# Access Compliance Report

## Public Rights-of-Way

Intersection ID: 30252	Main Street: CENTENNIAL_DR	Cross Street: WYLAM_DILLY_CT	Location:	N
ADA ID: 50BC56DEFEF8	Ramp Type: BlendTrans1	Initial Pass/Fail: Fail	Overall Compliance: No	Severity Score: 8.75
Codes/Mitigation Info/Possible Solution		Field Measurements/Component Compliance

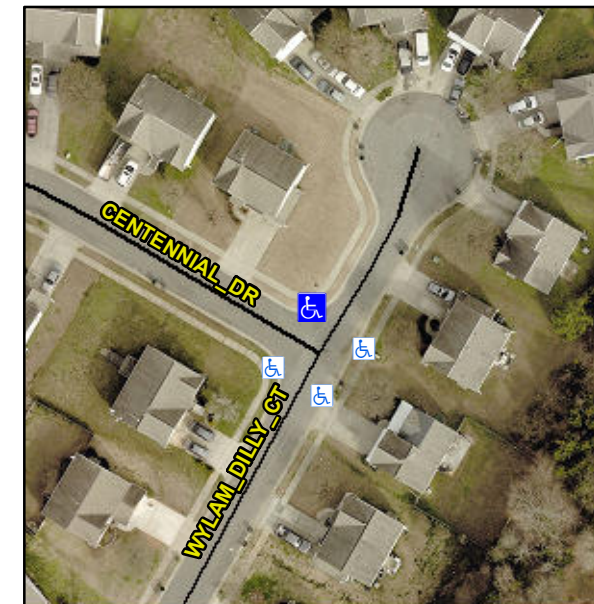
**CURB GAP 1.0**

**Not Found, R304.5.1**

**Remove & Replace Curb Ramp With Two New Directional Ramps or Equivalent.**
